## Release Notes

## SonicStudio HD

### Version 1.9.1

#### *AES/EBU Dialog*

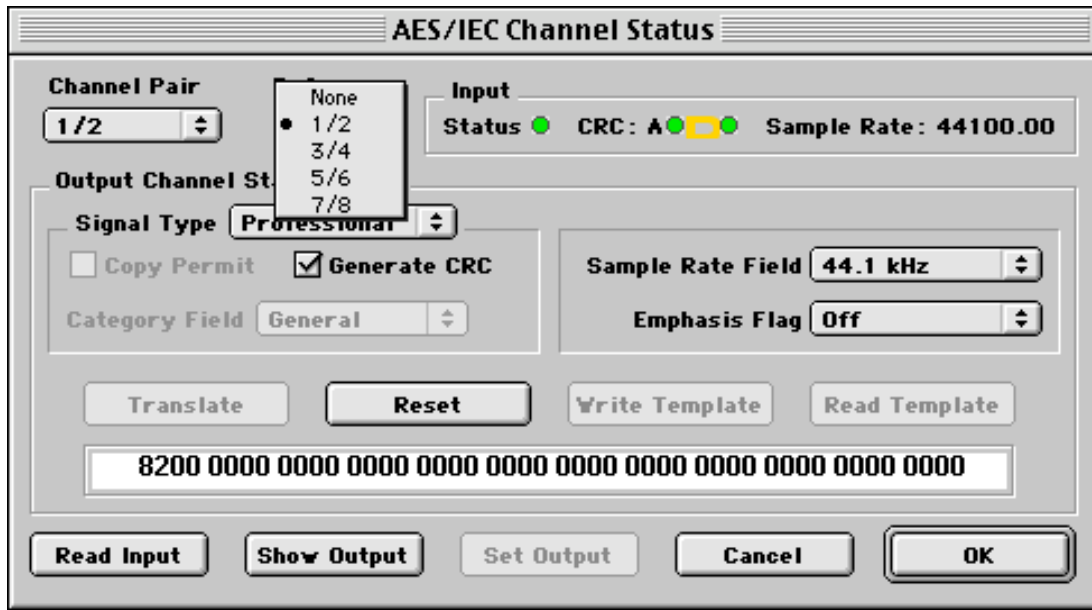
A new "Reference" pop-up has been added, which allows the user to force the status bits of any given channel pair to mirror the channel status of this global setting. This feature saves time when setting more than one output pair.

If any settings shown on-screen differ from the current hardware setting for that channel pair, the “Set Output” button will become active. Note that this pop-up setting is saved in the Preference file, forcing the application to start up according to the last saved state. Note that this is a global setting for the box, even though it appears in the AES/IEC Channel Status dialog.
